# Monthly Specification Update

***Intel® Server Board S3420GP***

*Intel Order Number E82362-009*

**December 2011**

Figure 1. HDD Incompatible Status

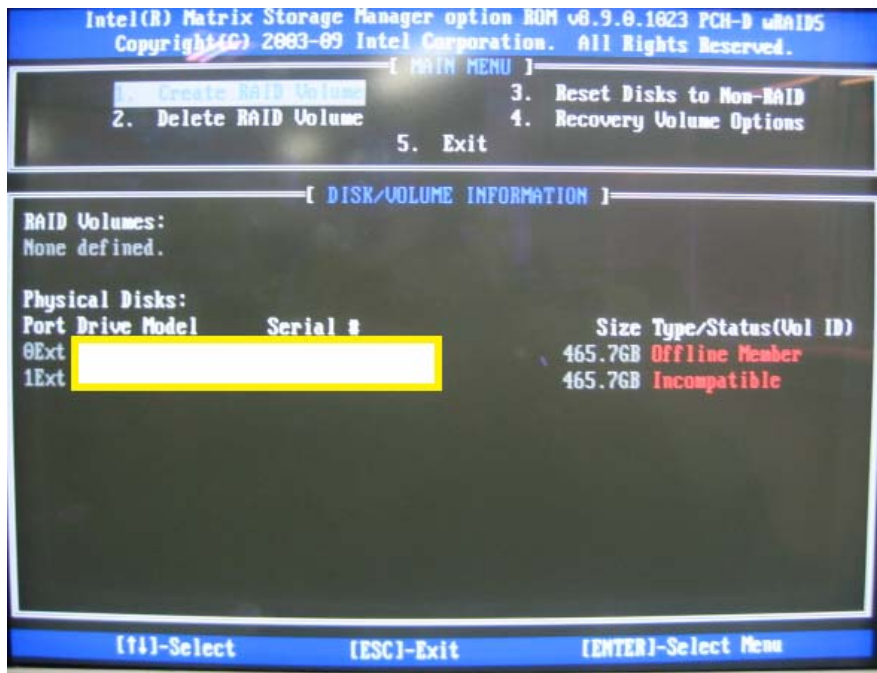
## 21. Intel® Matrix Storage Manager of Intel® Rapid Storage Technology (Intel® RST) may show HDD incompatible status under certain conditions

Problem	Under RAID 1 mode, if the operating system does reboot after one HDD is unplugged, the other HDD will show incompatible status even after the other HDD is plugged in again.
Implication	Please refer to the picture below.

Status	This issue was fixed in BIOS version 0048.
Workaround	Downgrade BIOS to version 0042 when the issue is happening.

Figure 2. Post Change Installation Procedure

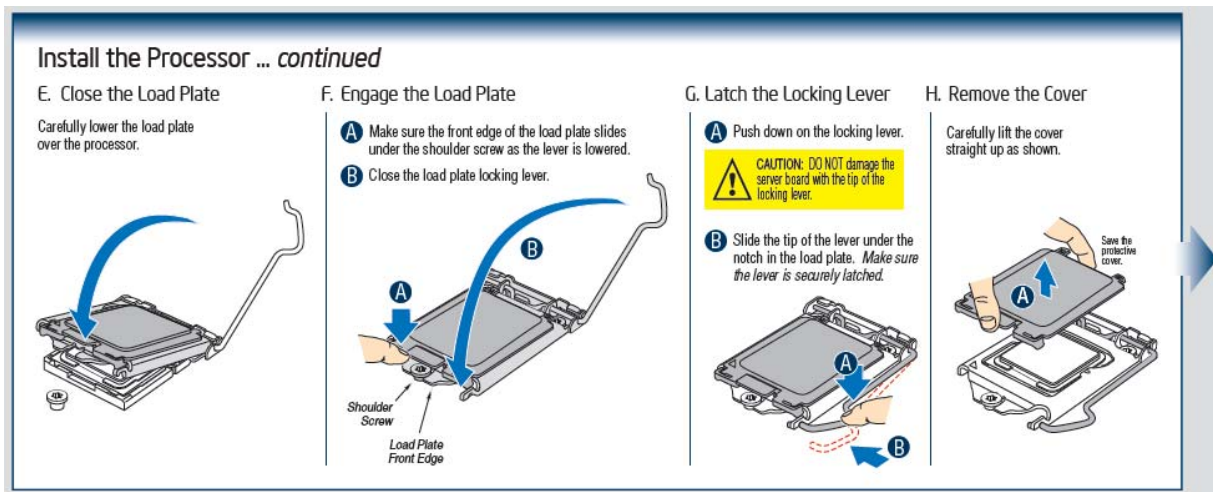
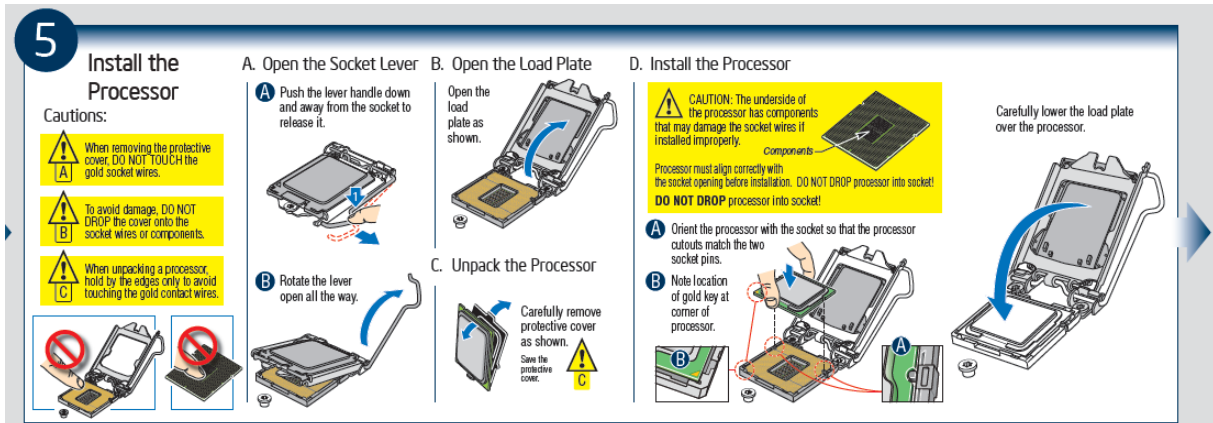
## 6. Intel® Server Board S3420GP Quick Start User Guide update for the processor socket protective cover change

Implication To reflect the processor socket protective cover change, the following step will be the post-change installation procedure.
